## **Access Compliance Report Public Rights-of-Way** (Curb Ramps)

Intersection ID: 13854 Main Street: E PARK AV **Cross Street: SOUTH BV** SE Location: Initial Pass/Fail: Fail **Overall Compliance: No Severity Score:** 10 ADA ID: 79950FA90C29 Ramp Type: BlendTrans1

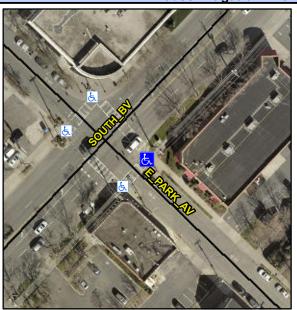
Street 1 Name Stop Condition-Street 1 Street 2 Name Stop Condition-Street 2 Possible Solutions: Remove & Replace Curb Ramp With Two New Directional Ramps or Equivalent.
